GOULBURN RIVER SOLAR FARM

Amendment Report

December 2023

Prepared by
Umwelt (Australia) Pty Limited
on behalf of
Lightsource bp

FIGURE 1.3
Design Refinements

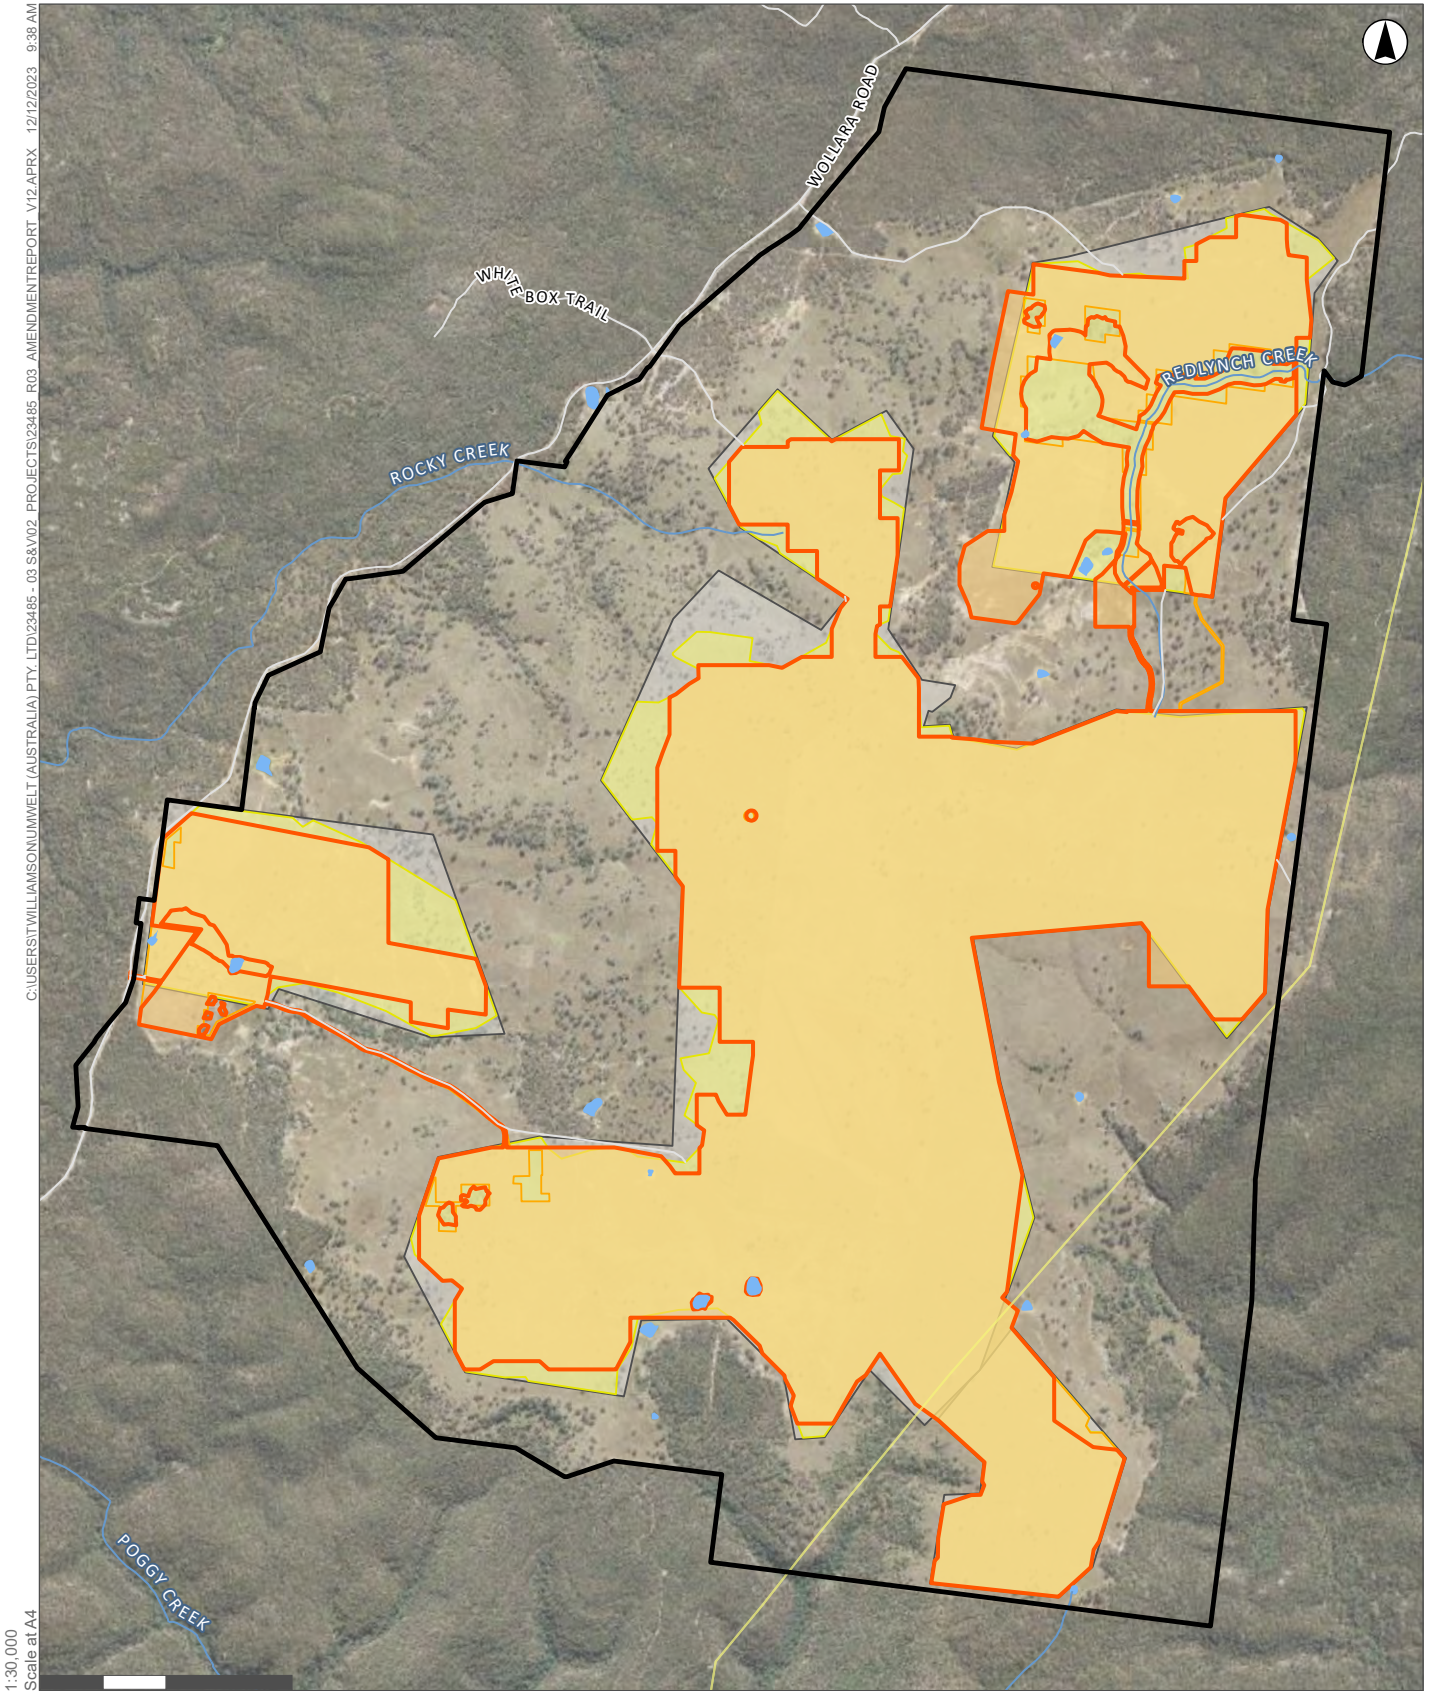
A summary of the key proposed amendments to the EIS Project are provided in **Table 3.2**, with an overview map provided in **Figure 1.3** below. The proposed amendments are described in detail in **Section 3.0**.

No.	Description
1	Transport route amendments – Transport route amendments to include the use of Barnett Street, and upgrade of the intersection of the Golden Highway and Ringwood Road.
2	Wollara Road and Ringwood Road Upgrades – Upgrades to additional parts of Wollara Road and Ringwood Road.
3	BESS Design Amendments – Increased centralised BESS capacity and option of a decentralised BESS as well as the option to host both centralised and decentralised BESS units.
4	<p>Development Footprint Modifications – Minor modifications to the Development Footprint and internal layout including and depicted in Figure 1.4:</p> <ul style="list-style-type: none"> • Removal of travelling stock reserve (TSR) 4481 from within the Project Area, although site access will continue to cross the TSR using the existing track. • Relocation and/or removal of solar arrays within the Development Footprint to avoid Regent Honeyeater habitat, scattered trees and Box Gum Woodland. • Increased width of selected internal access roads to accommodate subterranean power cables. • Realignment of the northern internal access road to avoid Regent Honeyeater habitat and Box Gum woodland.

5	Additional Transmission Tower – Construction of an additional transmission tower adjacent to the BESS/substation.
6	Workforce Accommodation – Revised approach for workforce accommodation.

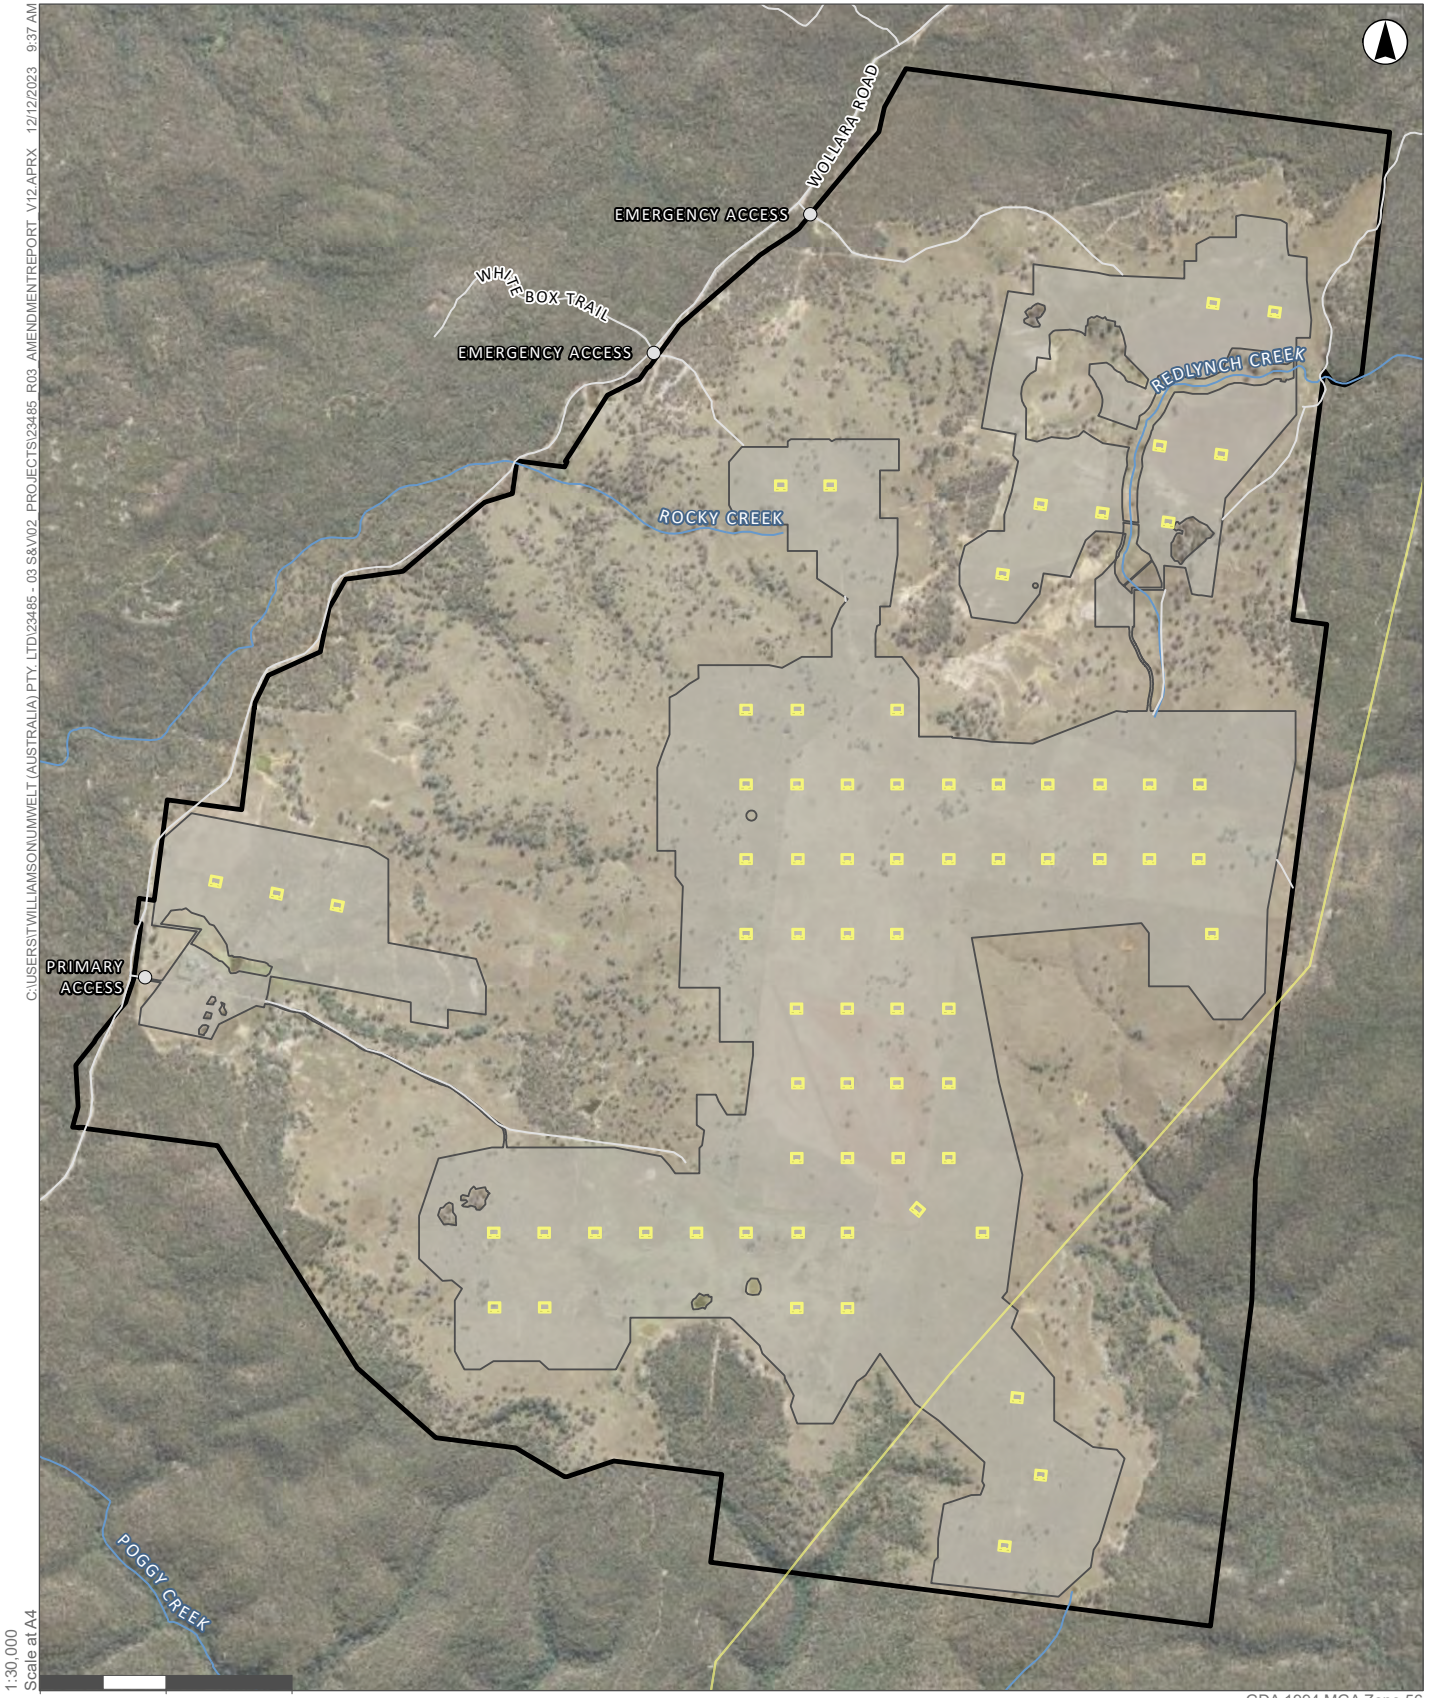
The positioning of solar panels and other Project infrastructure has been amended in response to comments received during the EIS exhibition stage and further consultation with NSW Biodiversity and Conservation Division (BCD) during the RtS phase.

Solar panels within the EIS Project Development Footprint have been relocated to previously unused areas within the Project Area to increase avoidance of PCTs and threatened species habitat, with a focus on reducing impacts to SAI entities. The access track between the central and north eastern areas of solar panel arrays has also been realigned, to minimise clearing within mapped important habitat for Regent Honeyeater and Box Gum Woodland.

FIGURE 1.4
Summary of the Proposed Amendments to Development Footprint

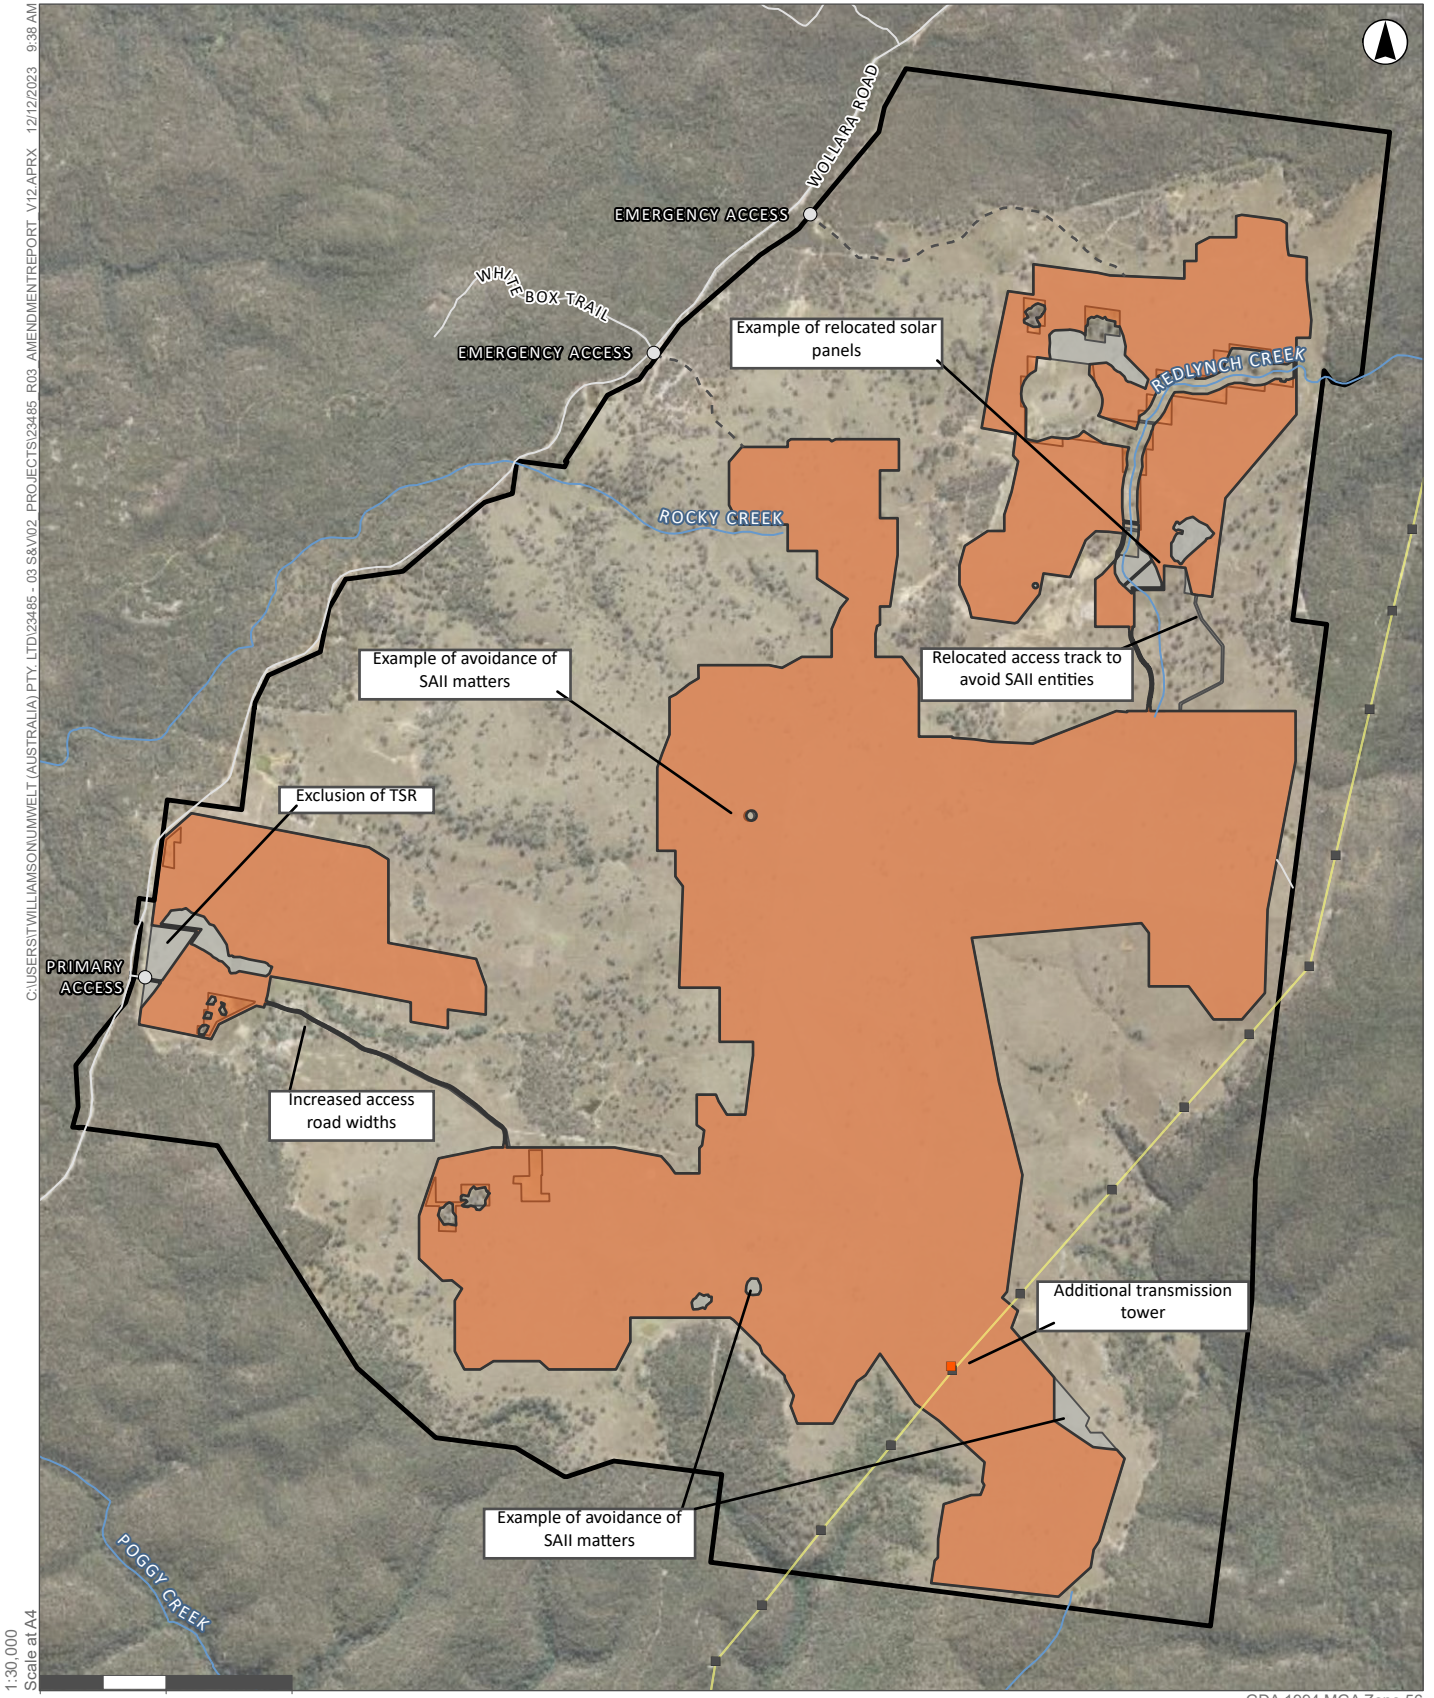
A transmission tower will be installed in the southeastern portion of Project Area as depicted in Figure 1.4 of the Amendment Report (copied here in **Appendix 1**), adjacent to the existing 500 kV transmission line easement. The transmission tower would be constructed at a height of approximately 65 m, in line with existing transmission towers within the Project Area.

FIGURE 3.4
Proposed Section of Road Sealing along Wollara Road

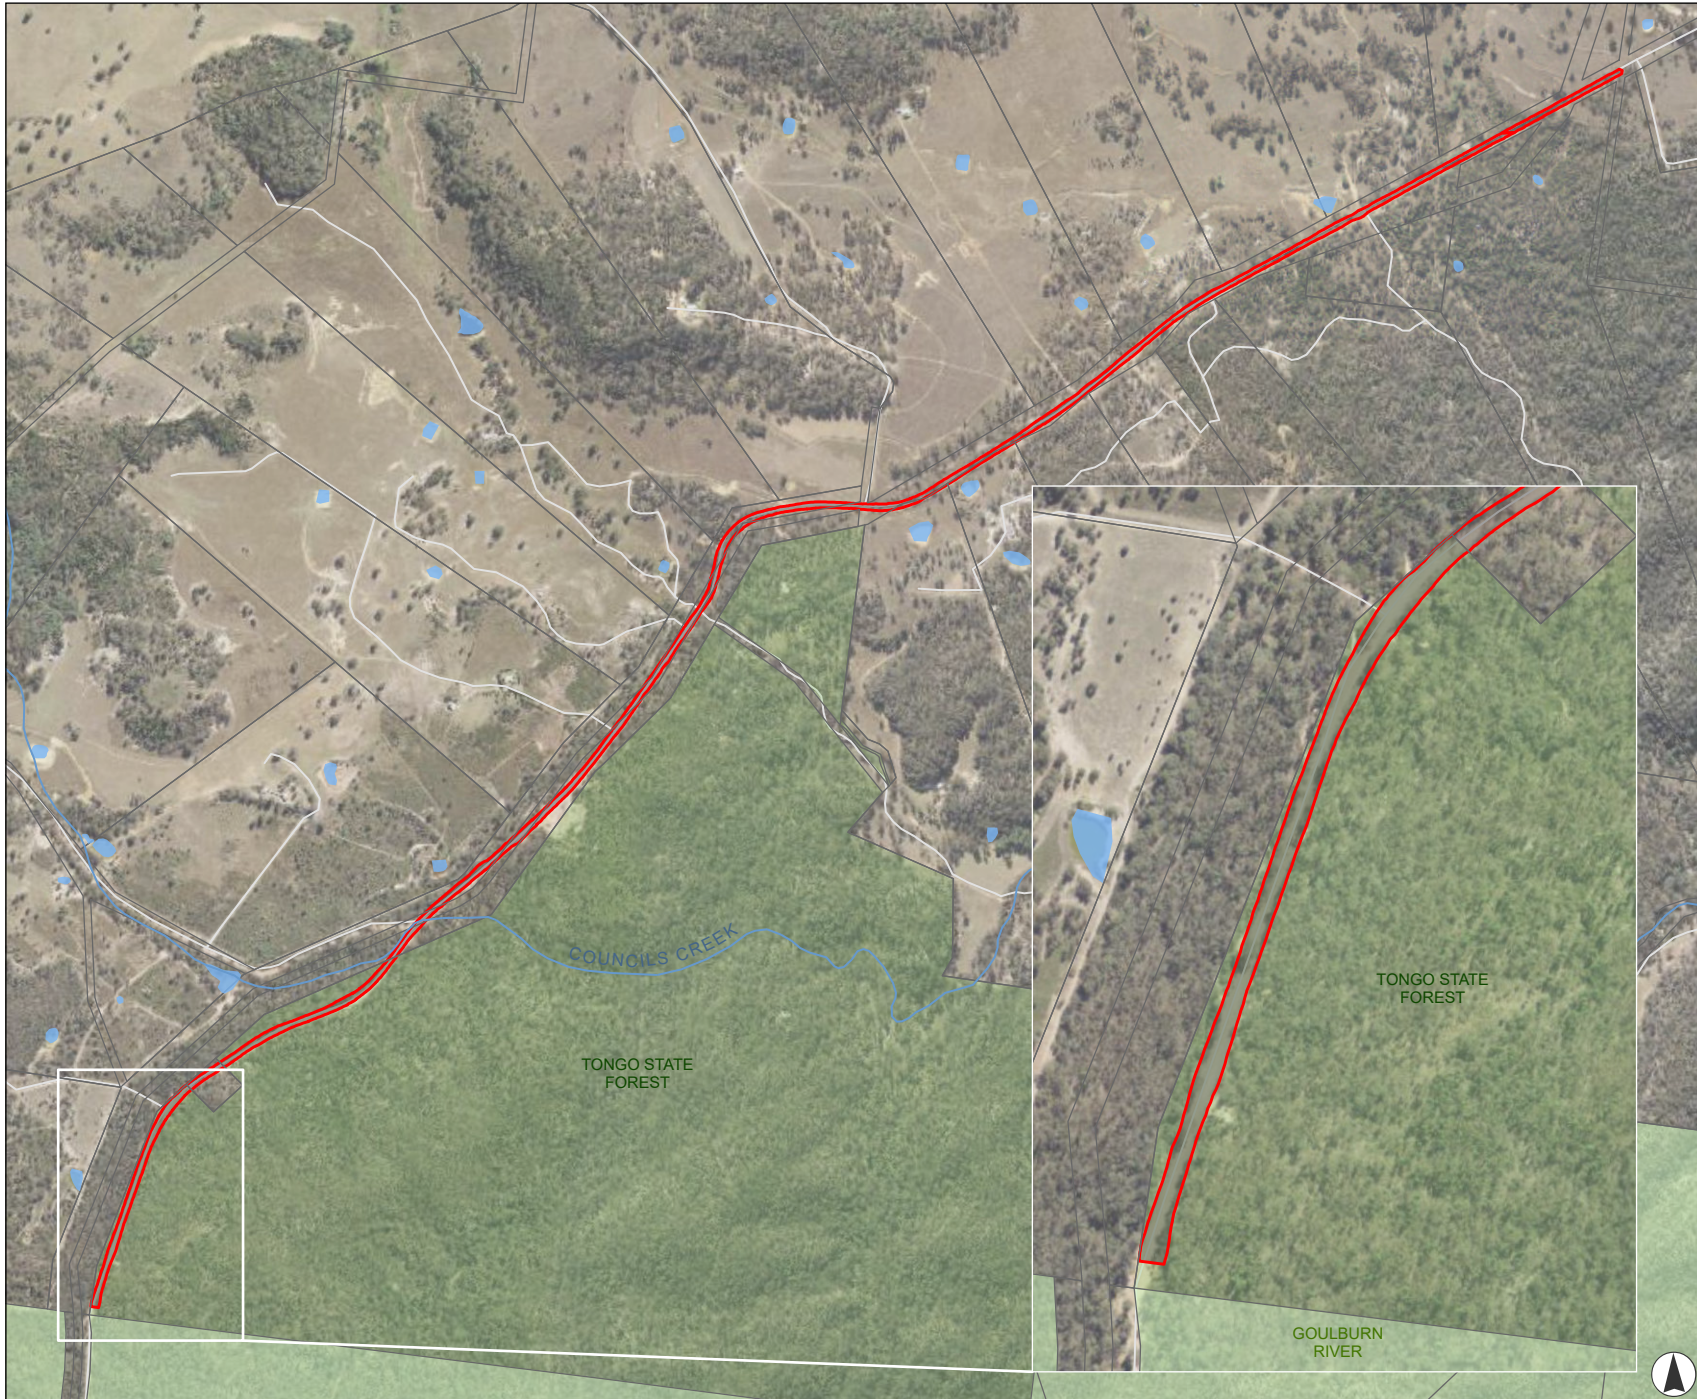
LSbp are now proposing additional road upgrades as community benefits under the Voluntary Planning Agreement (VPA) with the UHSC. These works would also facilitate further improvements to enable the safe movement of heavy vehicles. The proposed road upgrades include:
